PRODUCT SERVICE NOTICE

REPLACEMENT OF CHARACTER SLUGS IN DATA PRINTER CORP.
CHAINTRAIN PRINTER CT-6644

FIELD CHANGE ORDER

Equipment Affected 2263, 2263V, 5570, 5571 Data Corp Chaintrain Printer

FIGURE 1 - GROUND STRAP INSTALLATION

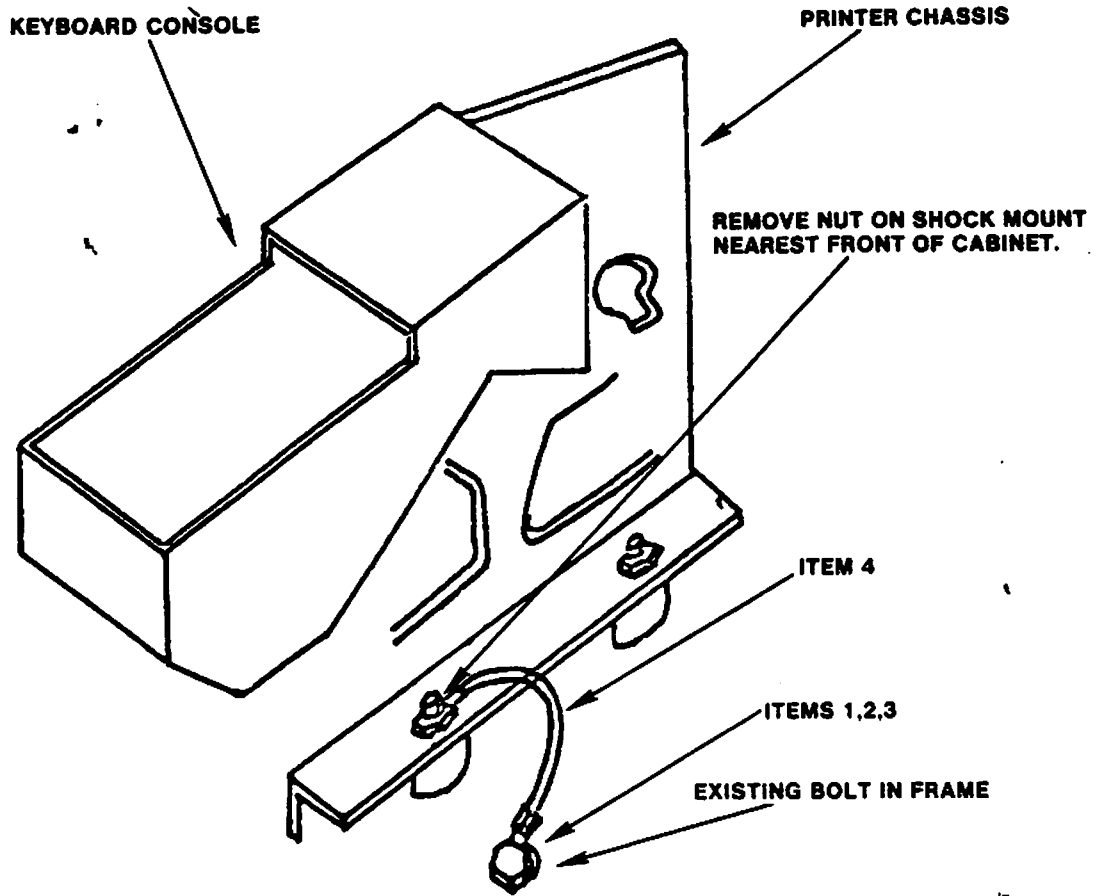
Some Type II data printers show intermittent problems of deselect, paper runaway, etc., which are caused by a high static electricity condition. These problems can be eliminated by taking steps to ground the printer keyboard console, the printer chassis and the top cover of the cabinet.

1. Power down the printer and make sure that the circuit breaker (CB1) on the power supply is turned off.
2. Remove the nut on the front shock mount for the end of the printer chassis on which the keyboard is located. The proper nut is indicated in Figure 1.

3. Install as short a wipe and lug assembly (Items 1, 2, 3 and 4) as is practical between the shock mount stud and the nearest frame bolt as shown in Figure 1.
4. Connect a similar ground strap between the corresponding shock mount on the other end of the printer chassis and the nearest existing hole in the frame.
5. Remove the keyboard from the keyboard console and then remove the console from the printer chassis (see Figure 2).
6. Remove paint from the console as indicated in Figure 2, by scraping and/or sanding, then reassemble the console and keyboard.
7. Mount two ground plates on under surface of the front skirt of the cover as shown in Figure 3.
8. Remove the rubber bumpers from the two cover rests and make sure that the surfaces under the bumpers are clear. Then verify that the ground plates firmly contact the cover rests when the cover is lowered.

FIGURE 1 PCB 210-7348 ASSEMBLY

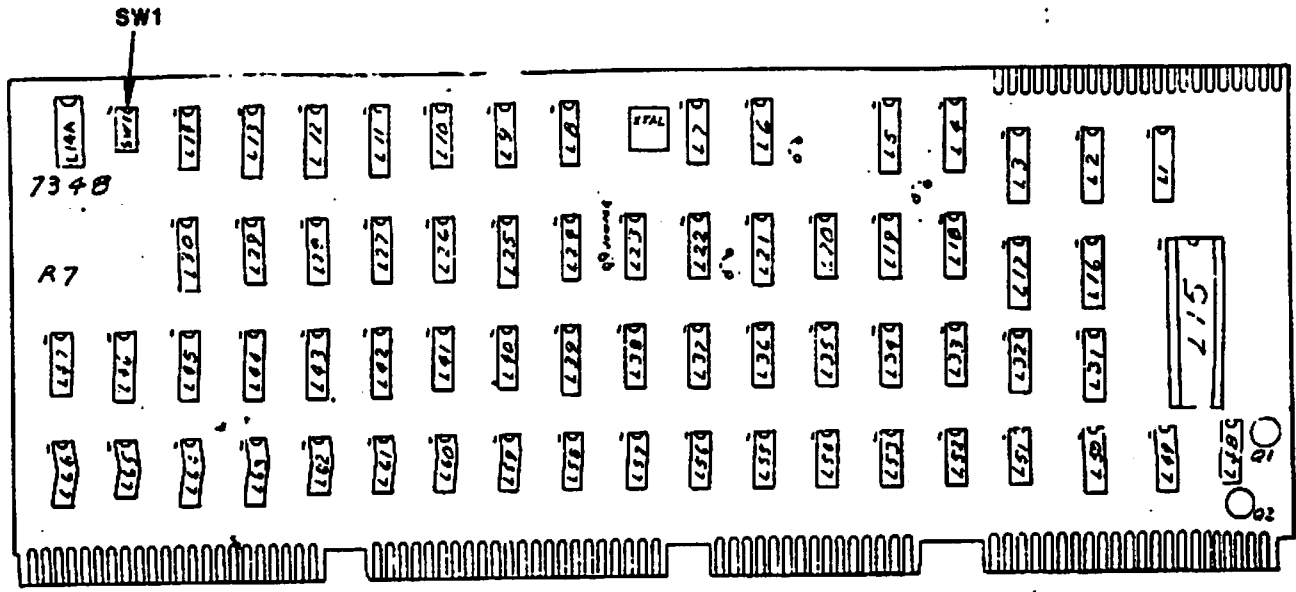
The switch banks (SW1) on the 210-7348 CPU board and the 210-7446 I/O board must be set as follows:

SW1	SW1
IO! IO!	IO! IO!
IF! IN!	IF! IN!
IF! ! !	IF! ! !
IX! 1 ! !	IX! 1 ! !
IX! 2 ! !	! ! 2 IX!
! ! 3 IX!	IX! 3 ! !
! ! 4 IX!	IX! 4 ! !
! ! 5 IX!	IX! 5 ! !
210-7348	210-7446

FIGURE 2 PCB 210-7446 ASSEMBLY

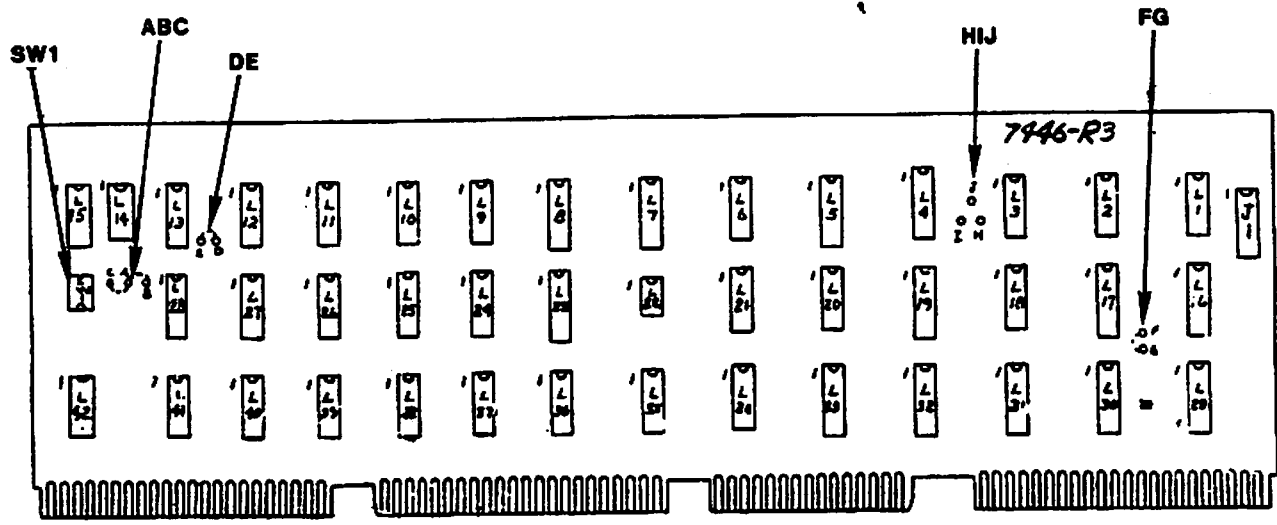
Jumpers must be installed on the 210-7446 board as follows:

HI - out
DE - in
AC - in
AB - out
GF - out
HJ - in (L42-3 to L32-14)

TB2 WIRING DIAGRAM FOR
SEQUENCER PCB WLI #210-7472

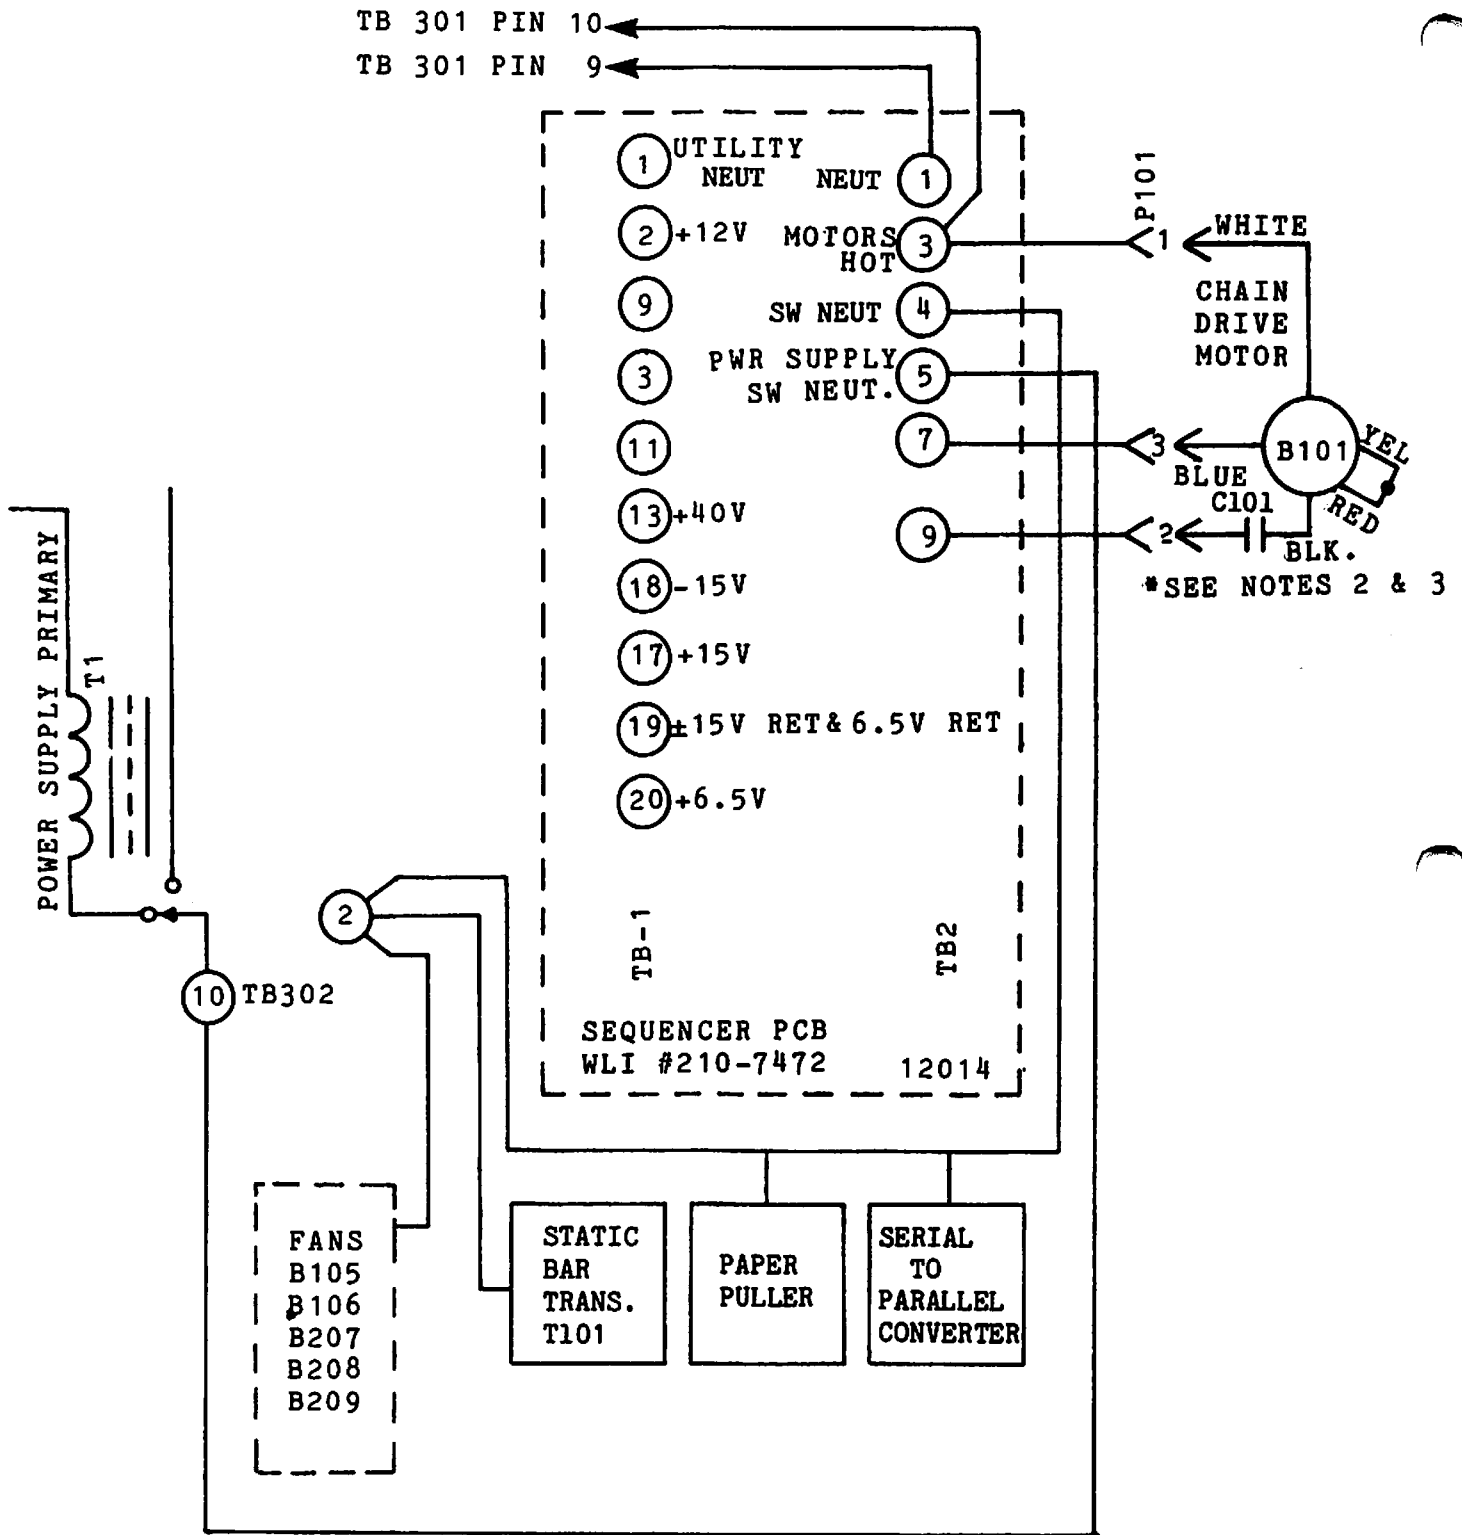
A new Sequencer Circuit Board, WLI #210-7472, has been added to the 2263 printer power supply to ensure correct powering-up of the printer. The new circuit board contains an additional triac (Q14).

Some printers have been shipped with the sequencer terminals wired incorrectly. CE's should check all newly delivered 2263 Printers to ensure that the TB2 terminals on the Sequencer Board are wired as follows:

- Terminal 4: Connects switched neutral to the serial-to-parallel converter, cooling fans, static bar, and paper puller.
- Terminal 5: Connects switched neutral to the power supply transformer via TB302.
- Terminal 7: Connects switched neutral to the motor run coil.
- Terminal 9: Connects switched neutral to the motor start coil.

2263/2263W: ECN on 210-7381 PCB

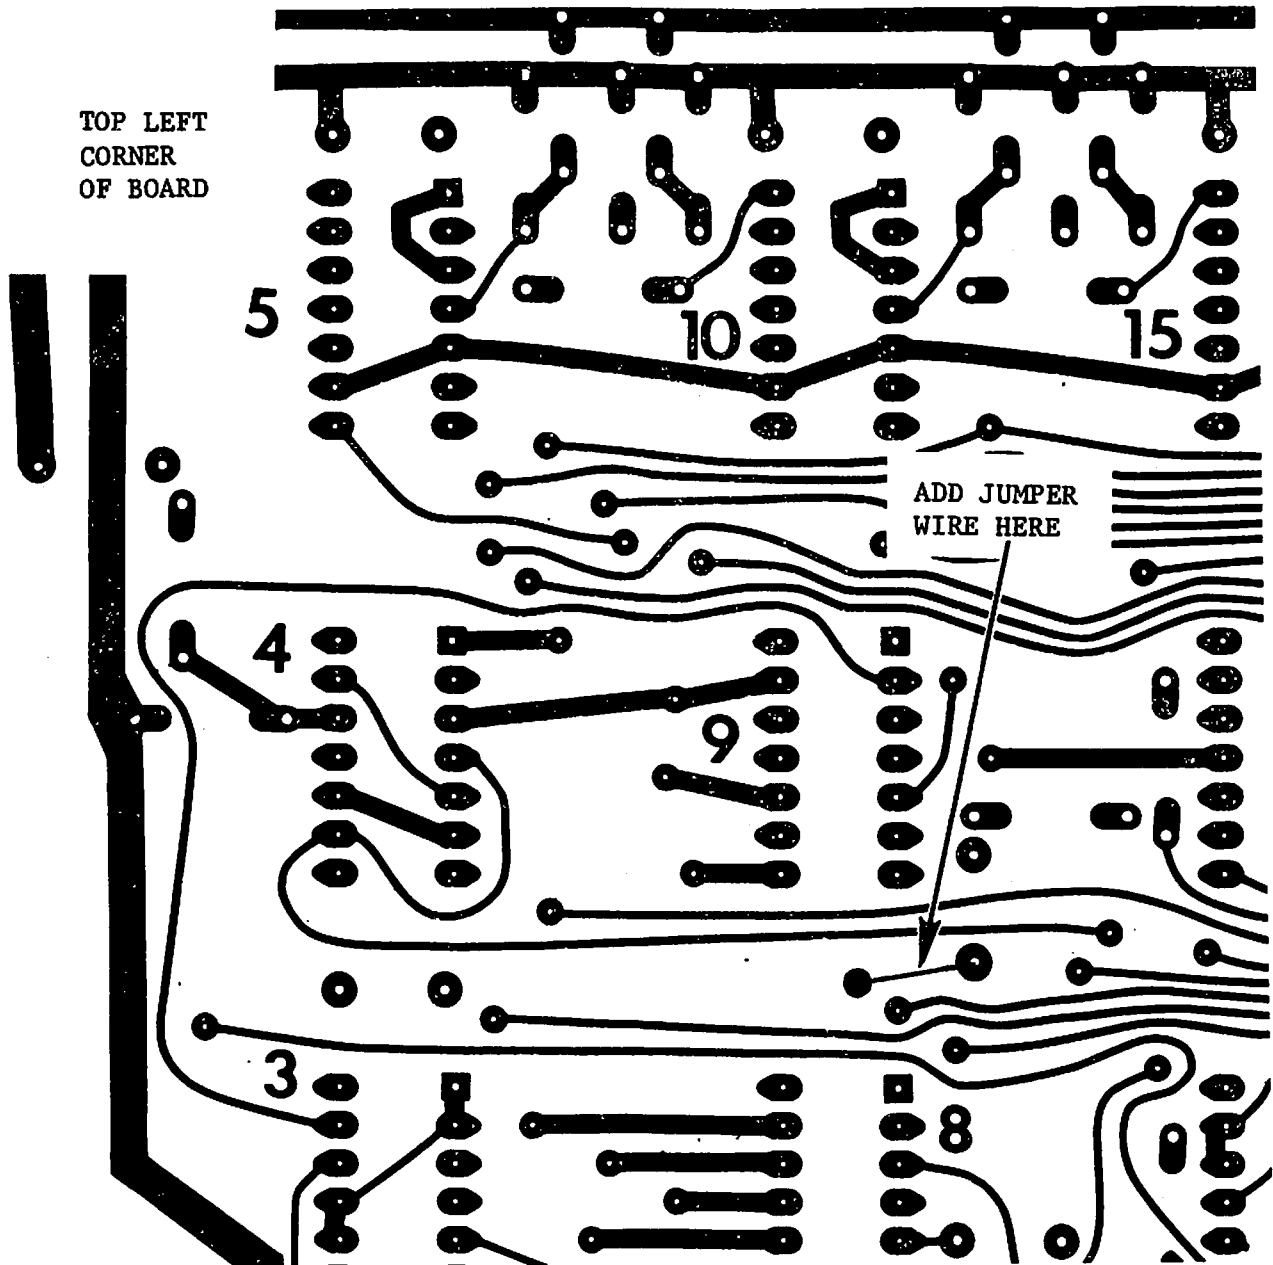
To prevent 'STOP' (deselect) problems.

Connect one side of C13 to $\pm 0V$. It is presently "floating".

1. Add a jumper wire on the non-component side of the board as shown in the figure below.
2. Test the modified circuit board in a printer by deselecting, and then reselecting the printer, while running an appropriate diagnostic.

FIGURE 1.

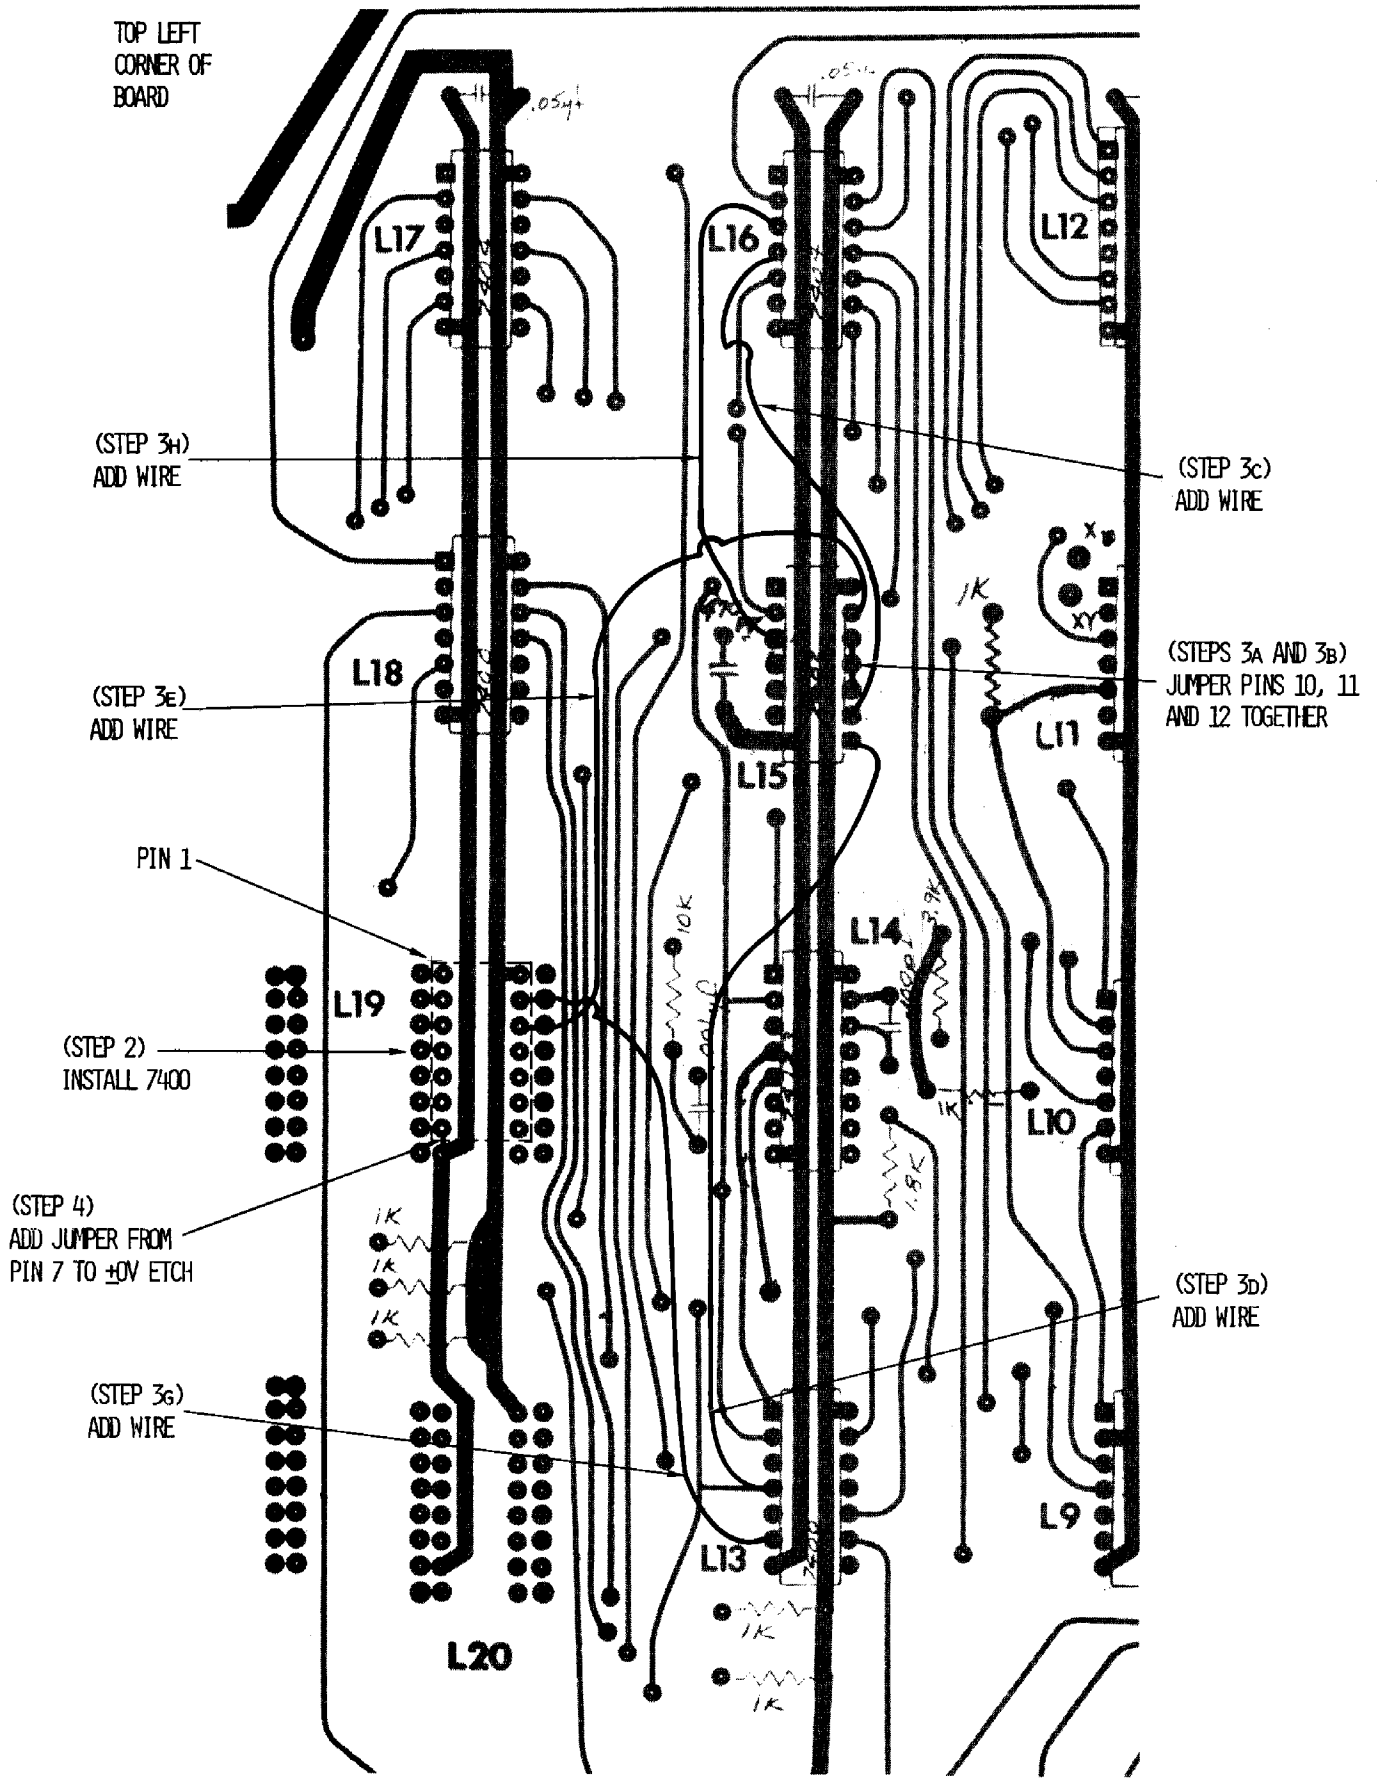
To prevent double line feeding and/or overprinting when printer is deselected, then reselected.

Add circuitry to ensure that when a STOP condition is pending, an ACKNOWLEDGE pulse is sent to the I/O controller at the end of the current operation.

1. Cut etch at L4 pin 2. Make cut at base of pin.
2. Install a 7400 type IC in location L19.
3. Add a wire FROM TO

a)	L15 pin 11	L15 pin 12
b)	L15 pin 10	L15 pin 11
c)	L15 pin 9	L16 pin 4
d)	L15 pin 8	L13 pin 4
e)	L15 pin 13	L19 pin 12
f)	L19 pin 11	L4 pin 2
g)	L19 pin 13	L13 pin 6
h)	L16 pin 3	L15 pin 3

4. Add a wire from L19 pin 7 to the $\pm 0V$ etch.
5. Change the E-REV label to 4.
6. Test the modified circuit board in a printer by deselecting, and then reselecting the printer, while running an appropriate diagnostic.
7. Update schematic to reflect this change.
